# Access Compliance Report

## Public Rights-of-Way

### (Pedestrian Signals)

Intersection ID: N/A	Main Street:	Cross Street: N/A	Location: N/A
ADA ID: 5E9DE5488914	Signal Type: One Push Button-Non APS	Overall Compliance: No	Severity Score: BTN 1: N/A BTN 2: N/A No BTN: N/A
Codes/Mitigation Info/Possible Solution		Field Measurements/Component Compliance

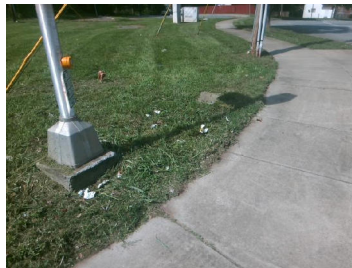
Surveyor Notes: TEXT HT 7/16

PROW/ADA: R410.6, TMUTCD 4e.08, R404.2, R404.3, R406.2, R404.7.3

Possible Solutions: Replace Signal Push Button With APS Button on New Post. Remove & Replace Sign.
